## **RFP #2025-07**

### **ADDENDUM #2**

**Issued 4/11/25**

Your attention is directed to the following interpretations of, changes and additions to the Contract Documents for the project, “Air Cargo Road Overflow Parking Lot & Maintenance Employee Lot” at Syracuse Hancock International Airport.

C307

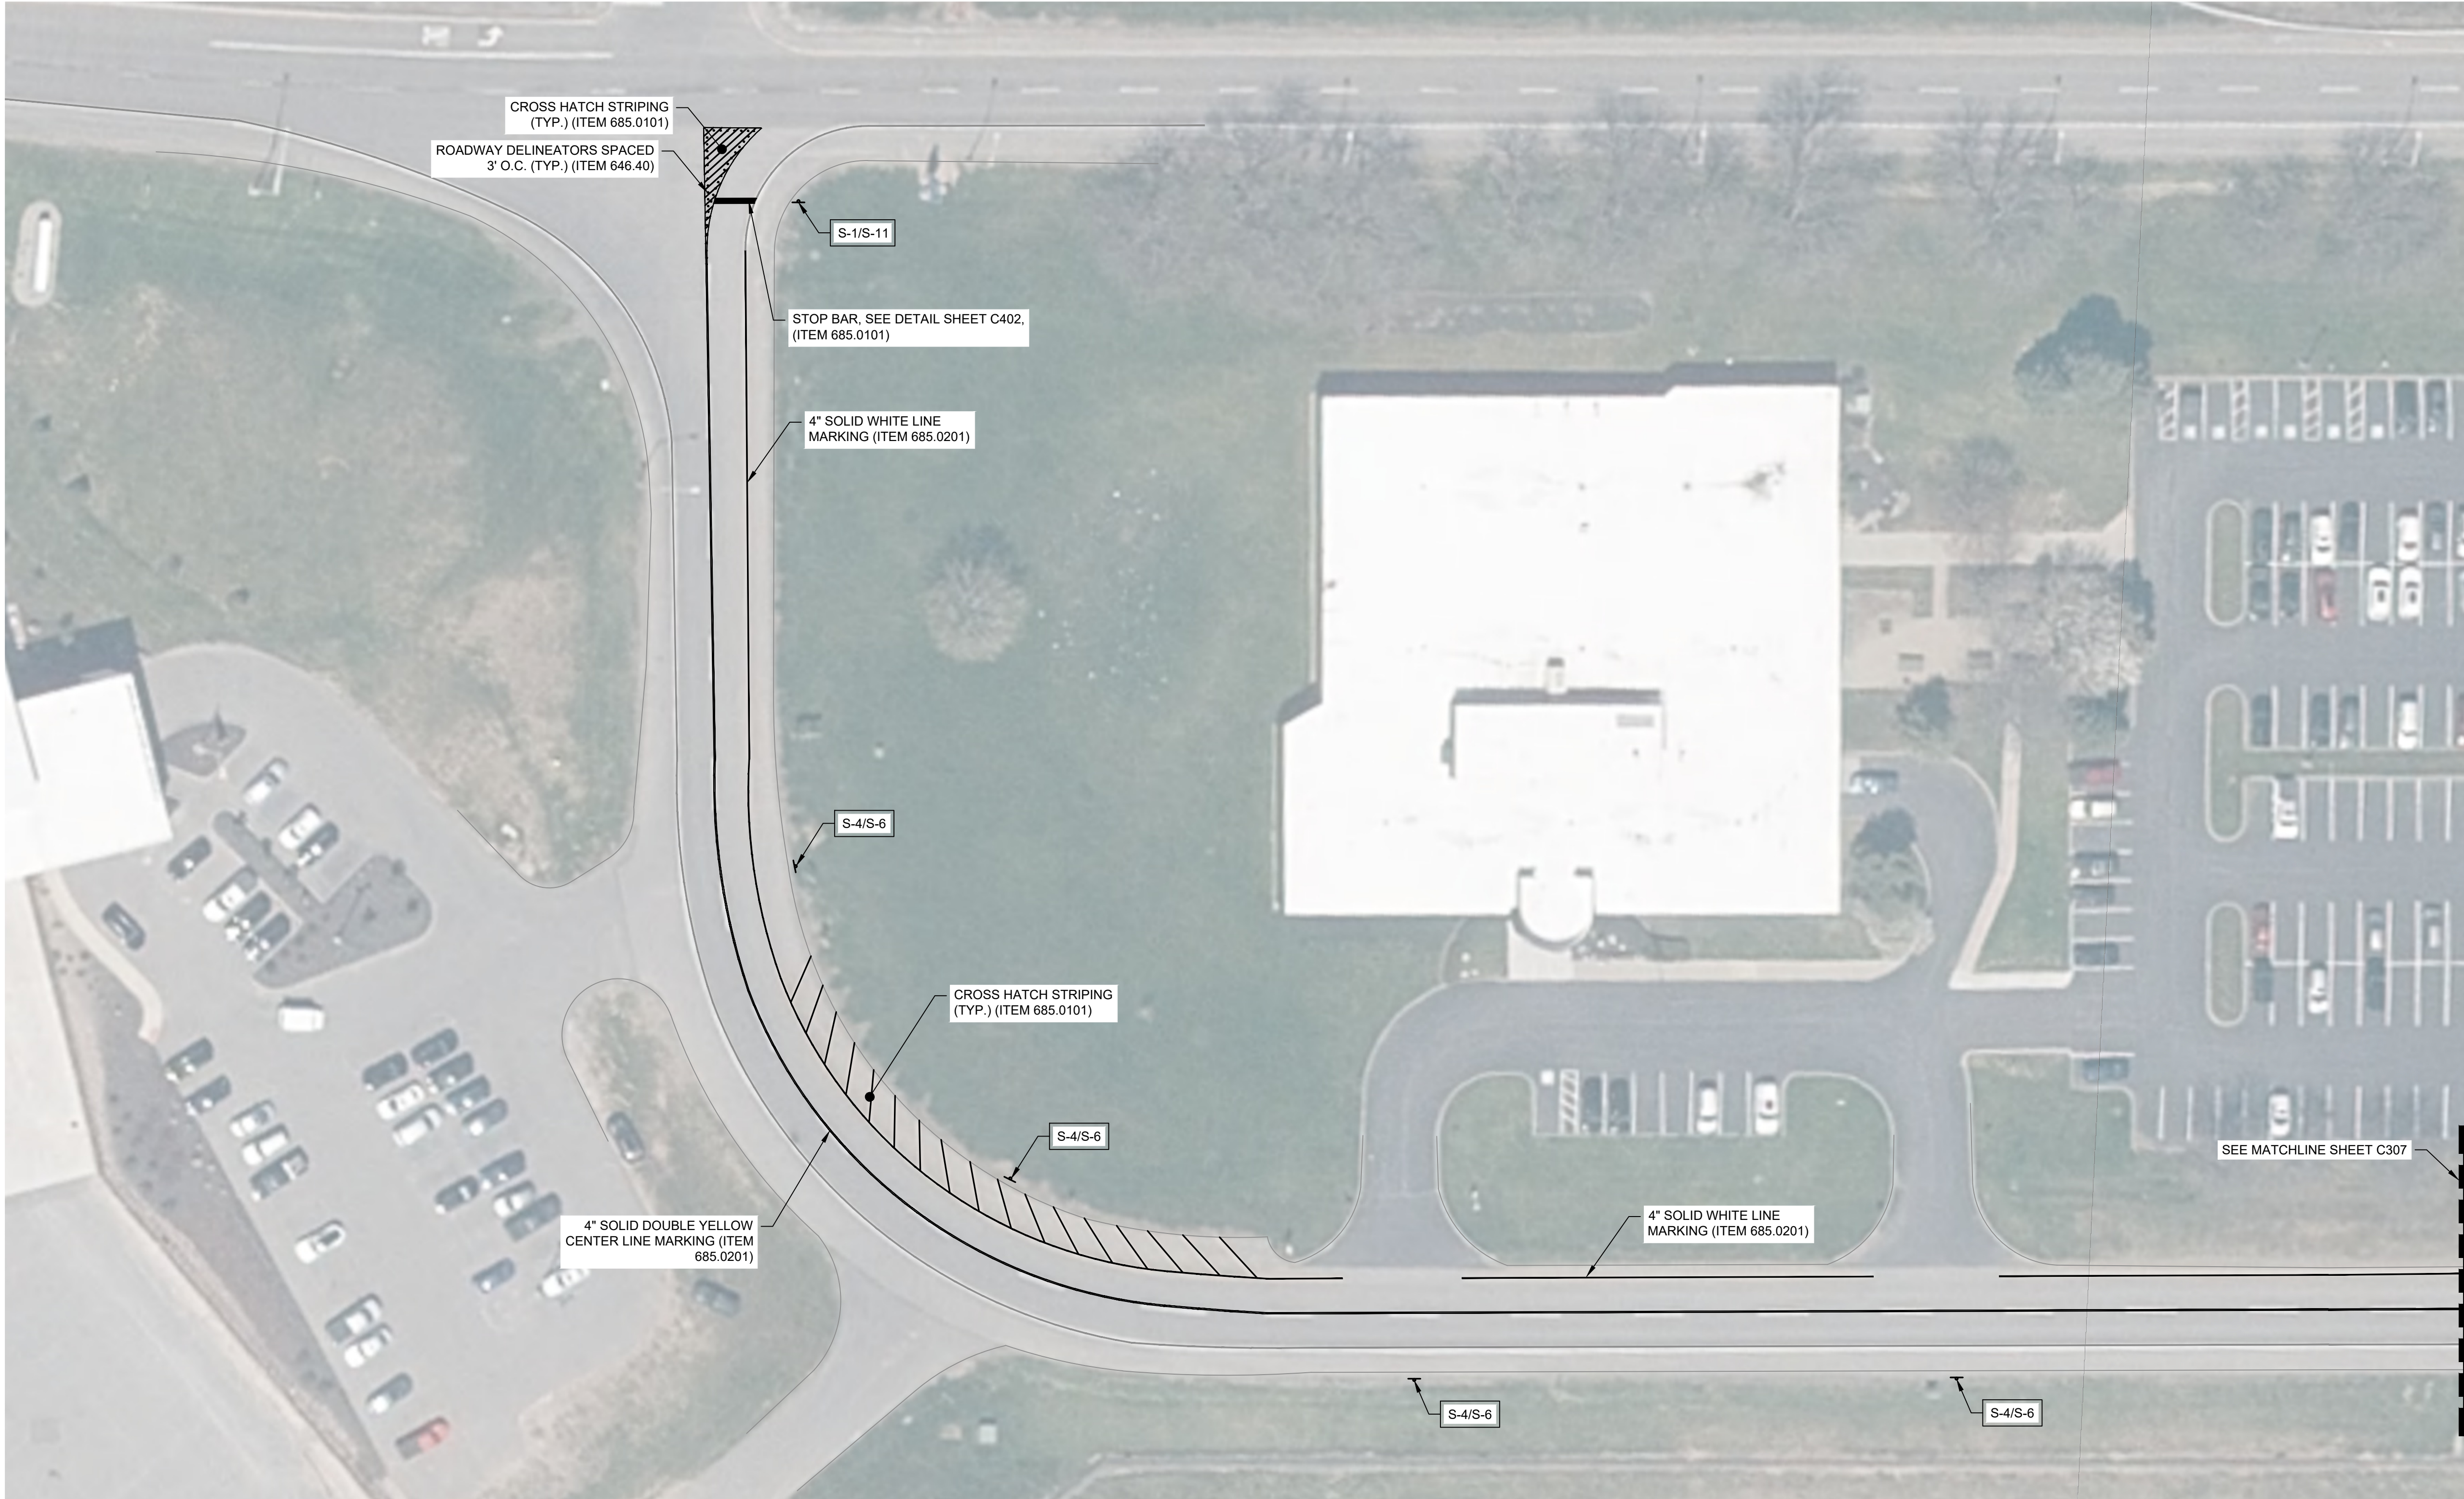
5. Revision: C303
  - Revision to roadway signage and striping.
6. Revision: C305
  - Subsurface utility depths added to the grading and drainage plan.
7. Revision: C307
  - Revision to roadway signage and striping.
8. Addition: C308
  - Offsite signage and striping plan added to reflect additional signage and striping items associated with the conversion of Air Cargo to two-way for the entire length of the roadway.
9. Revision: C309
  - Subsurface utility depths added to the utility plan. Light poles LP-1, LP-2 and LP-3 repositioned to not conflict with existing utilities.
10. Revision: C404
  - Signage table chart updated to signage changes and additions along Air Cargo Road.
